SUBMISSION: DRAFT MAMRE ROAD DEVELOPMENT CONTROL PLAN

This submission has been prepared by Urbis Pty Ltd on behalf of ICON Oceania, in response to the release of the Draft Mamre Road Development Control Plan (**draft DCP**) by the Department of Planning, Industry and Environment (**DPIE**) in November 2020.

Figure 2 Field validated Watercourses

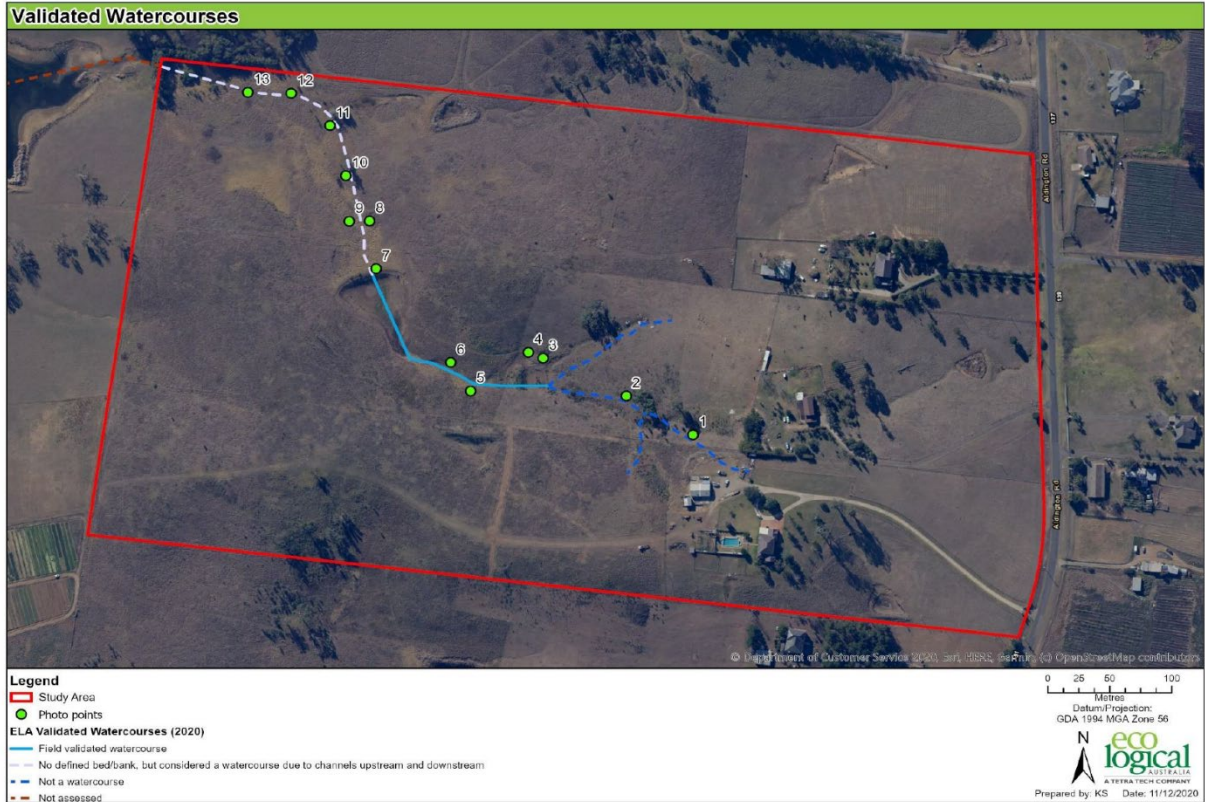
Eco Logical Australia (ELA) have undertaken a Riparian Constraints Assessment of the E2 Environmental Conservation zoned land traversing the subject site to ground truth the mapped watercourse and establish the quality and presence of vegetation. The ELA assessment established that the mapped watercourse does not meet the definition of a ‘river’ in accordance with the *Water Management Act 2000* (WM Act) in some places with no bed or banks, whilst in other sections it is a more defined channel linking farm dams (see **Figure 2**).

The field survey demonstrates that the mapped watercourse or ‘river’ is in very poor condition, with some reaches having no defined bed or bank and others being dominated by exotic grasses and weeds.

Given the degraded nature of the limited vegetation present, large occurrence of weed species through the site and the large farm dams buffering high velocity flow and erosion, ELA considered it unlikely that the mapped second order watercourse within the study area links remnant native vegetation with the riparian biodiversity system of the Wianamatta-South Creek Biodiversity Corridor.

Given the mapped watercourse is in very poor condition and will be impacted significantly by earthworks both on the site and on surrounding sites there is a strong argument for its relocation and consolidation to improve its ecological function and facilitate appropriate stormwater conveyance.

Figure 3 Indicative Section 1

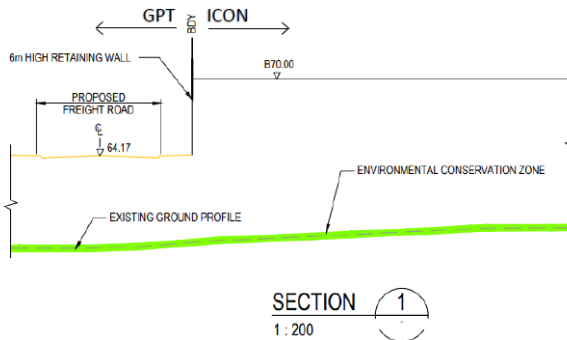
Preliminary engineering advice from AT&L has identified that given the fixed points of Aldington Road to the east and the dedicated freight corridor (freight road) to the west (levels provided by TfNSW), significant retaining walls (potentially up to 10m high) will be required across the site to create typical building pads suitable for industrial use. Internal roads have been indicatively designed to be compliant in terms of grade with an intersection at Aldington Road which will be required for access to the site.

Figure 2 below is an indicative section prepared by AT&L illustrating the variation in ground levels along the northern boundary of 113-127 Aldington Road, Kemps Creek. The section uses the levels of the proposed freight road (provided by TfNSW) as it runs through the GPT site at 784-786 Mamre

The section illustrates that to the west of the site at grade connectivity within the existing E2 Environmental Conservation zoned portion of the site and adjoining sites through the freight road corridor is not achievable.

Figure 5 Indicative Trunk Drainage Infrastructure

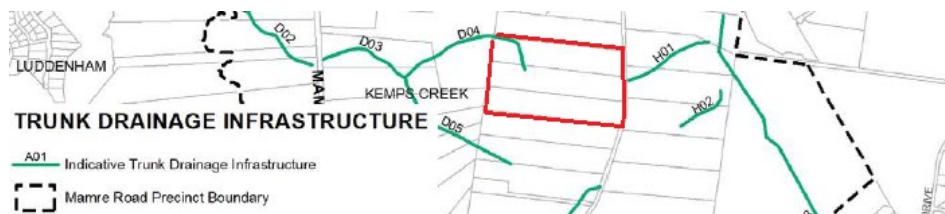
The DCP shows an Indicative trunk drainage line running through the subject site which is identified in the draft Mamre Road Section 7.11 Plan for acquisition by Penrith Council. The mapping of trunk drainage elements is considered premature since limited modelling has been undertaken by the NSW Government. The linking of trunk drainage elements to indicative watercourses will prevent the realignment and relocation and consolidation of watercourses following ground truthing, ecological studies and detailed hydrological modelling of post development ground levels.

Control 11 states “Development consent must not be granted on land which is to be serviced by this infrastructure until such time as it has been delivered to the satisfaction of the trunk drainage manager (Council or other).”

- Figure 6 and Control 11 in relation to trunk drainage should be removed from the DCP to allow site specific modelling and an appropriate assessment of post development landforms.
- The mapping of trunk drainage elements should be removed from the DCP since limited modelling has been undertaken by the NSW Government.

Figure 6 Landscape Features and Visually Sensitive Locations

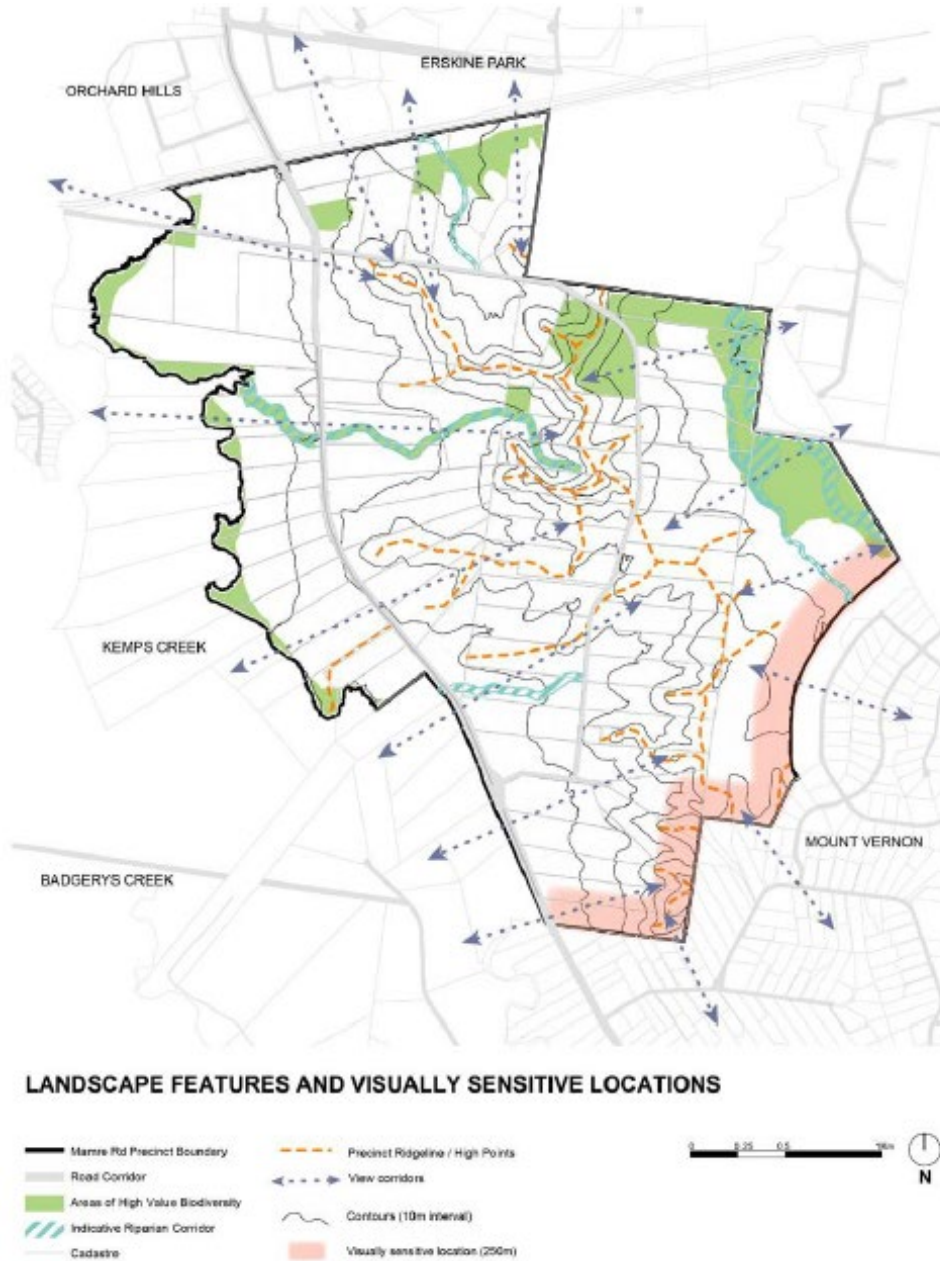
The DCP prescribes controls that intend to mitigate the impacts of Industrial Development to these corridors and visually sensitive locations. This section of the DCP conflicts with the very purpose of the Mamre Road Precinct, which is to provide employment through industrial and warehouse development.

Industrial development requires relatively level building sites and given the existing topography of the Precinct significant earthworks will be required to facilitate this. The scale of earthworks required will alter the existing landscape and change the topography patterns.

Recommendation: The current DCP controls are misaligned with the future industrial nature of the Mamre Road Precinct. It is recommended additional commentary is included acknowledging the fact that views and vistas will ultimately be altered across the precinct as a result of the intended Industrial Development and associated earthworks.

Figure 7 Road Network Map (Figure 14 of draft DCP)

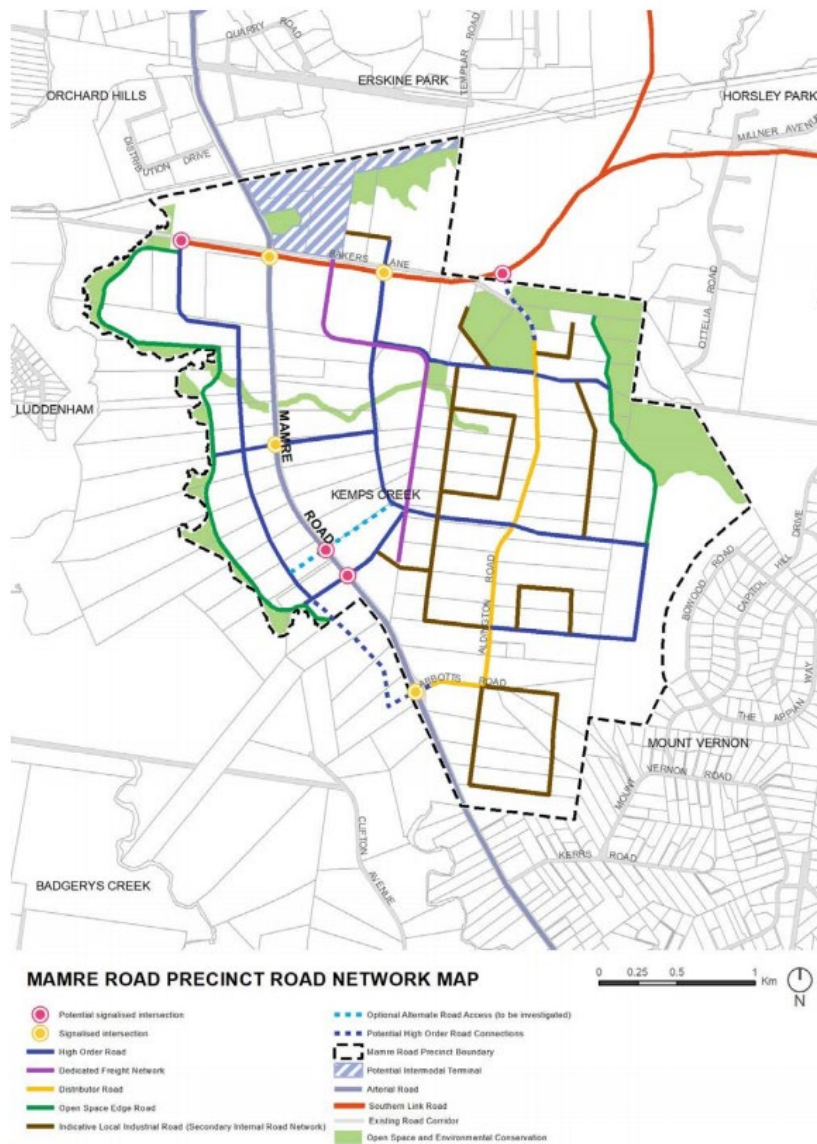
The Road Network Plan identifies Aldington Road as a key north south distributor road with limited access points and no direct access from existing lots.

Control 6 states “No direct vehicle access to Mamre Road or Southern Link or distributor roads are permitted”. Further consultation with landowners and assessment of the number and location of intersections with Aldington Road should be undertaken

Given the fragmented nature of the land holdings temporary access to distributor roads will be required until the broader network connections are established.

- **Control 6 stating no direct vehicular access to distributor roads should be revised to allow site specific modifications where it can be demonstrated that an alternate road layout can satisfy the objectives of the draft DCP.**
- **The DCP should include a provision allowing temporary access to Aldington Road for sites constrained by the proposed internal Road Network.**
